SPB Number: 2024.0105

MECHANICAL UPDATES

Issued: 05/10/2024

STANDARD PLAN BULLETIN NOTICE
RaceWay Engineering and Construction Division

- Sheets: A150, A501, M120
- Attachment: A150, A501, M120

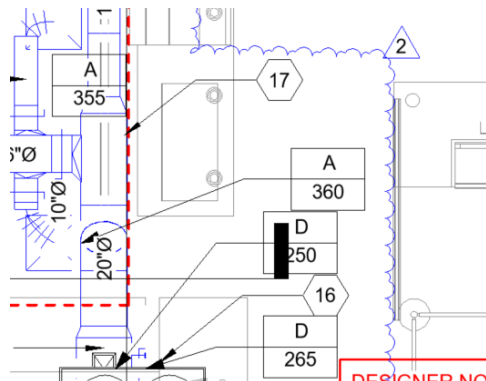
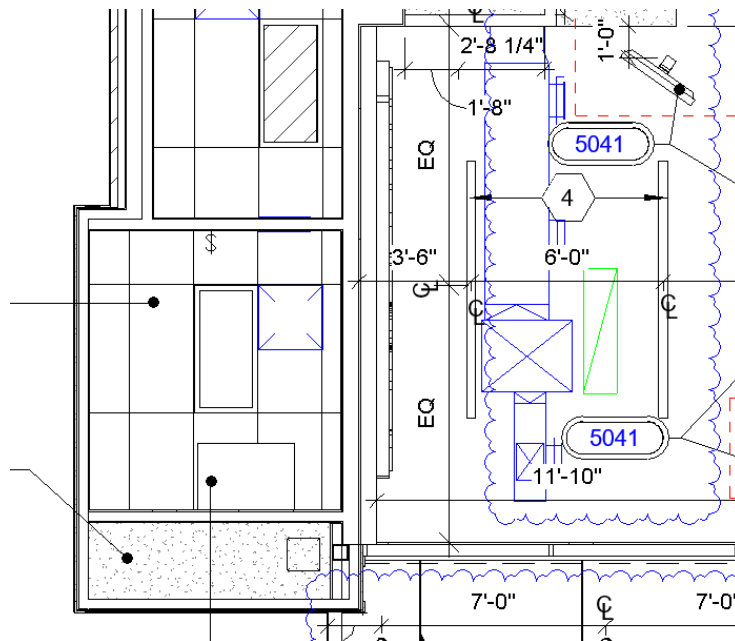
- MINIMUM MECHANICAL DUCT HEIGHT:** Note added by Mechanical to indicate minimum AFF for mechanical ducts to avoid being installed too low

SHEET KEYNOTES	
16	BOTTOM OF DUCTWORK SHALL BE INSTALLED MIN. 11'-0" A.F.F. TO AVOID OBSTRUCTION OF RACEWAY SIGN BEHIND CASHWRAP.
17	DASHED OUTLINE REPRESENTS LOW PART OF SOFFIT. INSTALL SUPPLY AIR DUCTWORK WITHIN LOW SOFFIT. COORDINATE WITH ARCHITECTURAL DRAWINGS.

- Sheets: A201, M002
- Attachment: A201, M002

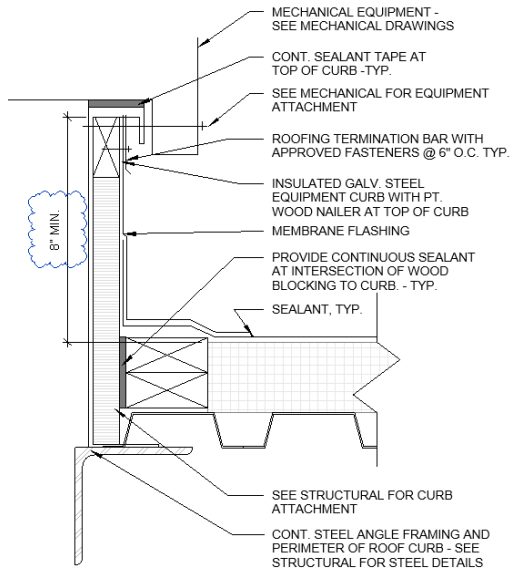
3. ROOF CURB: Roof curb dimension updated to 8" min.

1. PROVIDE UNITS WITH INSULATED MATCHING ROOF CURB, WITH MINIMUM HEIGHT TO MOUNT BOTTOM OF EQUIPMENT 8 INCHES ABOVE ROOF SURFACE. COORDINATE WITH ARCHITECTURAL ROOF INSULATION THICKNESS.
